# CITY OF ALBUQUERQUE

RE: **Signal Village Subdivision**  
**Grading Plan**  
**Engineer's Stamp Date 4/20/2018**  
**Hydrology File: C20D078**

Based on the information provided in the submittal received on 10/04/2017 the above-referenced Grading Plan cannot be approved for Preliminary Plat until the following are addressed:

**GRADING AND DRAINAGE PLAN**

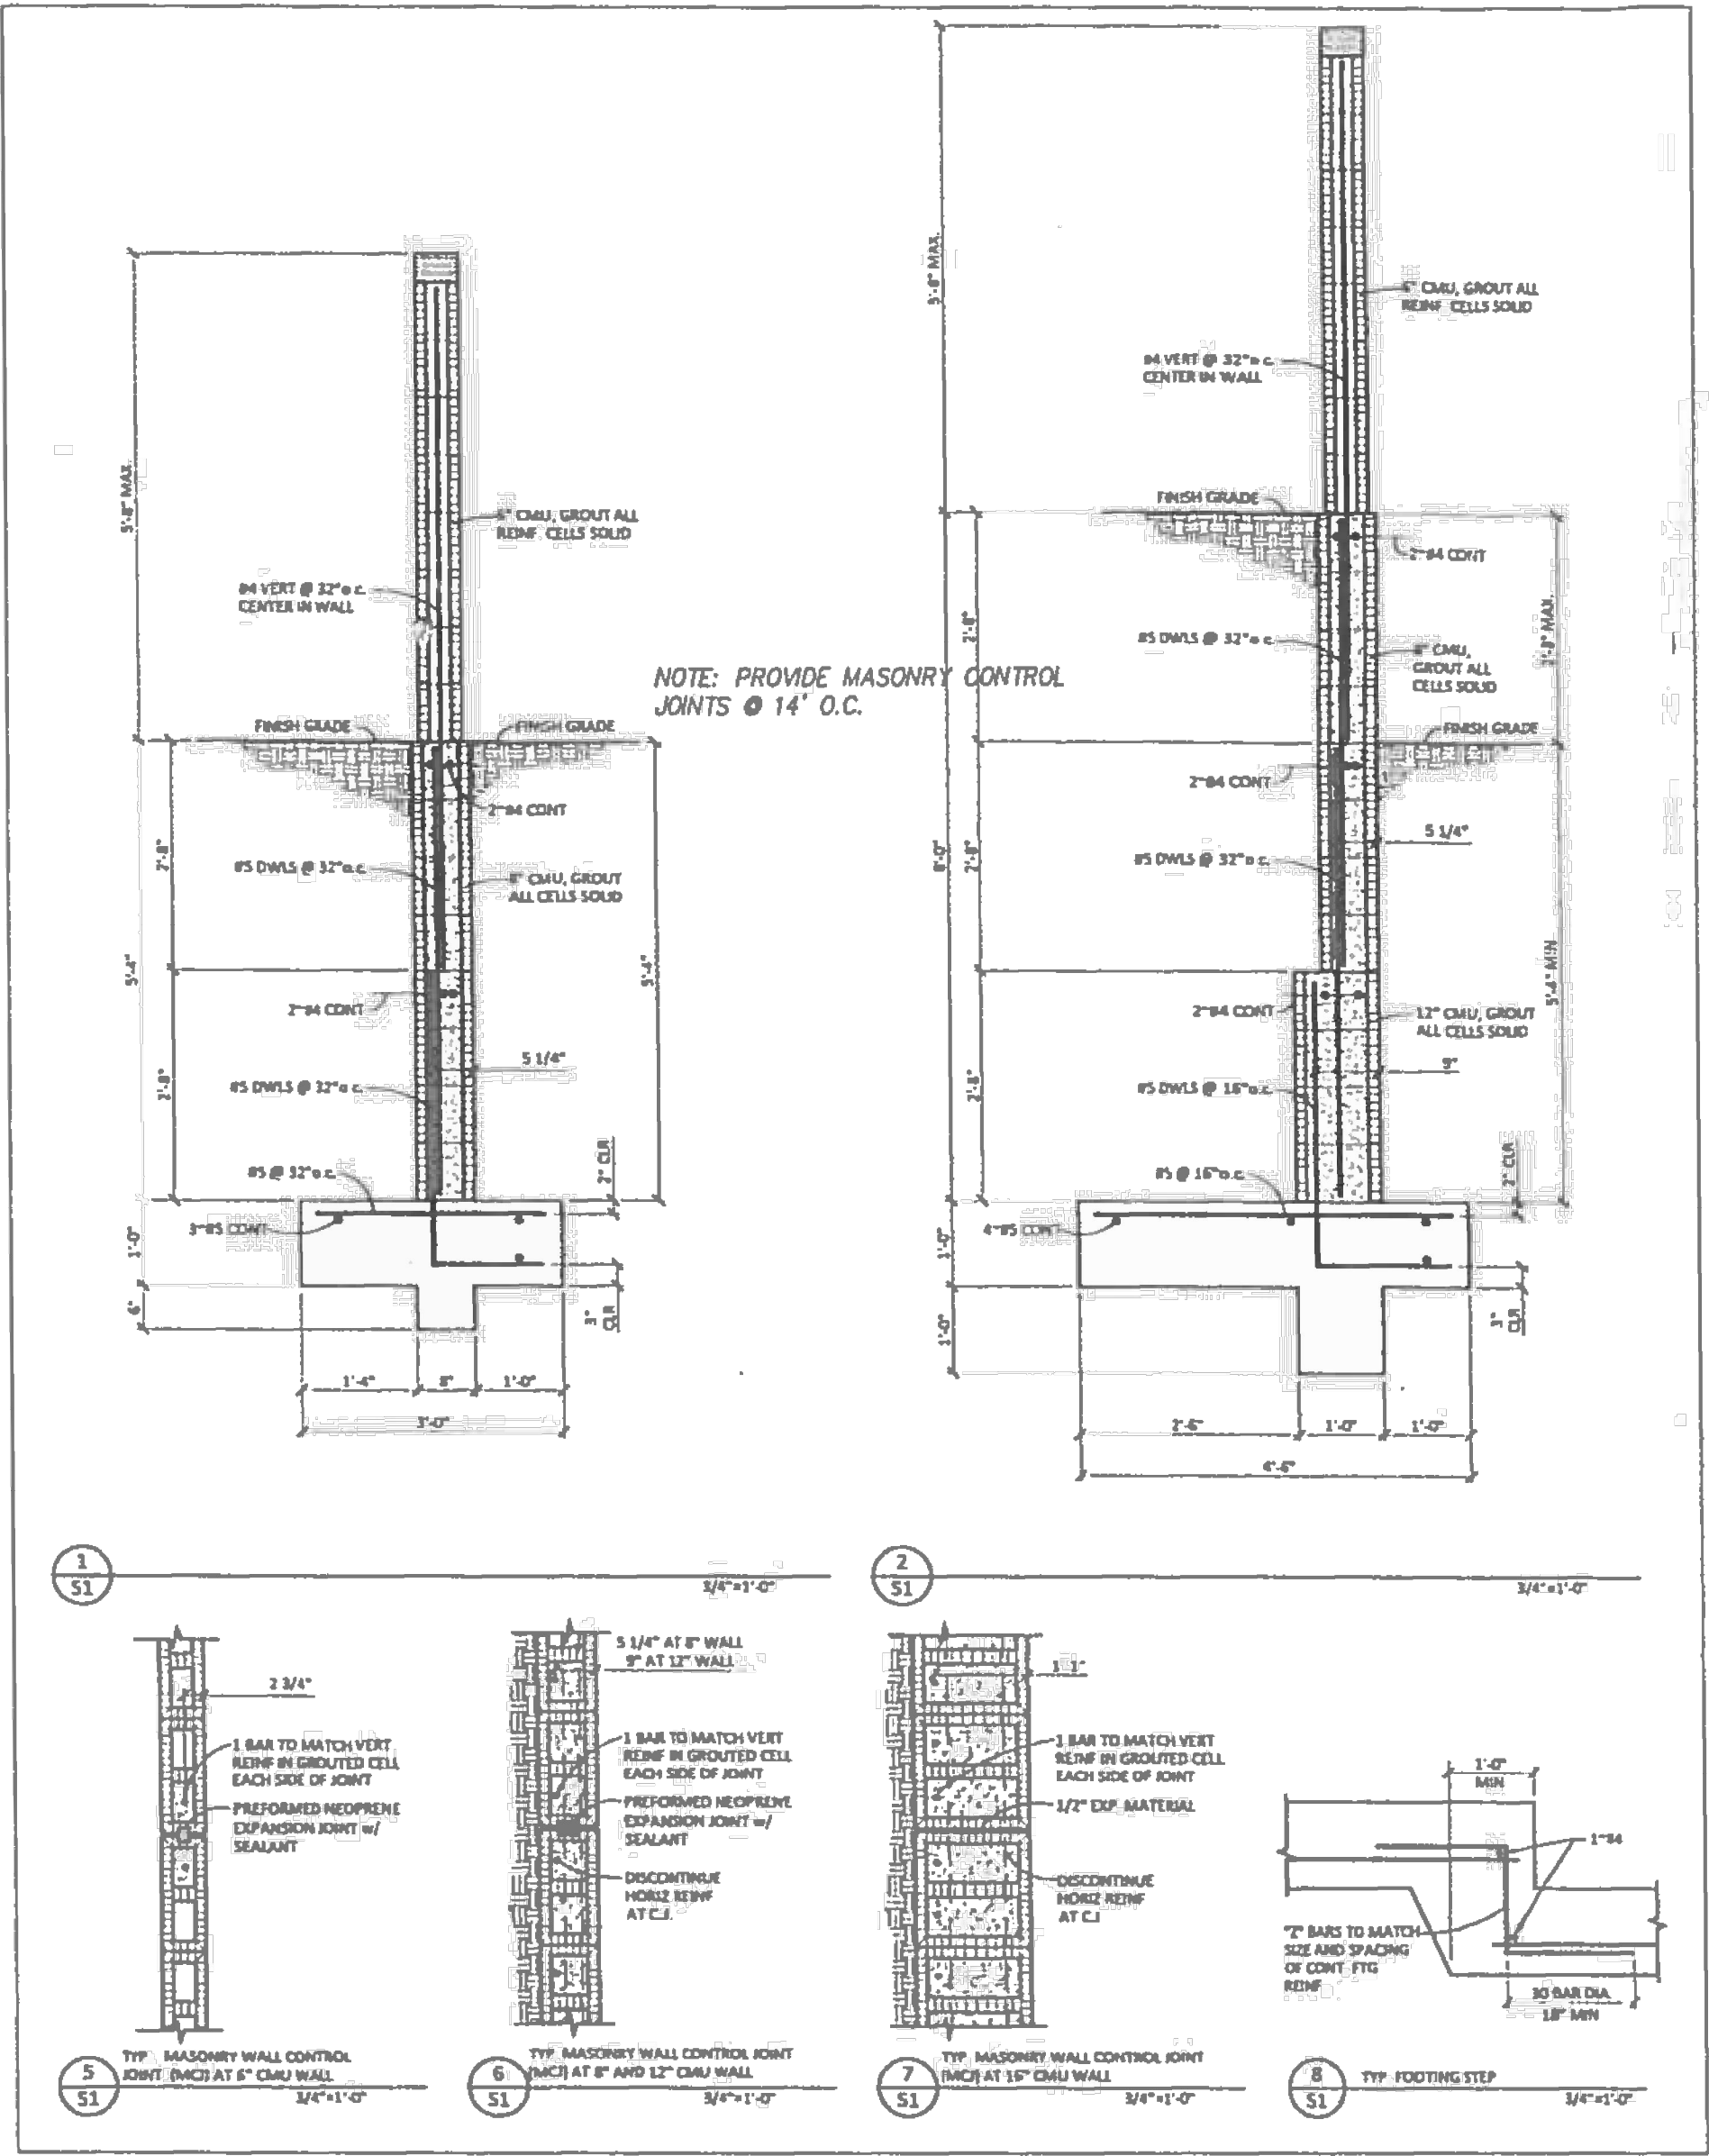
1. Show the existing and proposed property lines and right of way dedications.
2. Provide first flush calculations, and show details of the proposed facilities.

3. This site does not currently drain to Signal Avenue and the drainage from this development was not anticipated in the downstream drainage system, so developed runoff will not be allowed to Signal Ave.

5. Frontage improvements will be required on Ventura St. and Signal Ave. that must be shown on the G&D plan. Typical sections must be shown on the G&D Plan for all roads both onsite and offsite. The sections and the plans should show both the full planned width and the portion to be constructed with this project, along with any temporary transitions at the ends.

7. This entire site is in a FEMA Special Flood Hazard Area, SFHA. The improvements needed to remove the SFHA must be constructed, and then a Letter of Map Revision LOMR must be obtained from FEMA removing the floodplain from the development before any building permits will be allowed.

9. Detailed hydraulic calculations are required to demonstrate that the fill being placed in the floodplain will not increase the base flood elevation. HEC-RAS models are required in accordance with FEMA MT-2 instructions and should start with a model supplied by FEMA. Information request forms may be obtained on the FEMA web page. . The analysis must include HEC-RAS models of the "Duplicate Effective", "Corrected Effective", and "Revised" flood plains, beginning with the model acquired from FEMA thru a data request.

10. A topo work map and annotated FIRM are required with the analysis. A plan and profile of the La Cueva arroyo is also required showing stationing along the FEMA thalweg and station information for the proposed floodplain improvements. The profile and a typical section should show the scour depth measured from the existing arroyo invert elevation, and 2' of freeboard above the 100-year base flood elevations.

12. Written concurrence with the grading and drainage plan is required from the USACE indicating compliance with section 404 of the clean water act prior to approval of the preliminary plat. The limits of any Waters of the US must be shown on the Grading and Drainage Plan and conditions of any Section 404 permits must be stated on the plan.

REINFORCED CONCRETE MASONRY / SCOUR WALL  
NO SCALE

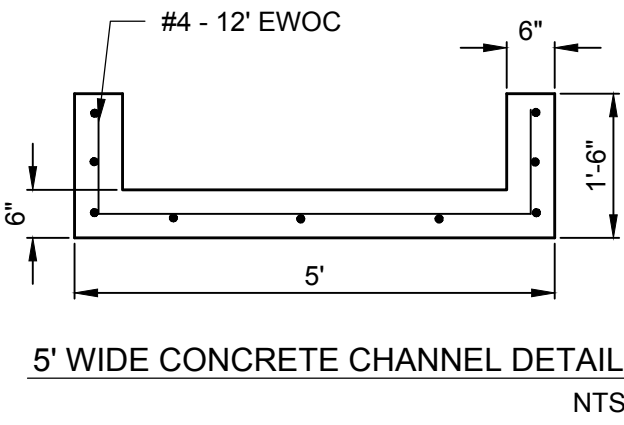
4. Typical sections are required at all retaining walls at the point of maximum retainage showing existing ground, proposed grades, lot lines, and dimensions. Wall footers must not encroach into public right of way or adjacent properties without a written agreement from the adjacent land owner.

8. Scour protection must be provided to protect the development from potential lateral migration of the arroyo. The potential lateral migration of the arroyo must be calculated. Development is usually encouraged to stay outside of the Prudent Limit. Any development within the Prudent Limit must be protected from potential lateral migration of the arroyo to the depth of scour calculated in accordance with the "Sediment and Erosion Design Guide". Parallel flow may be assumed over most of the length of the scour wall, but perpendicular flow must be anticipated at the upstream end.
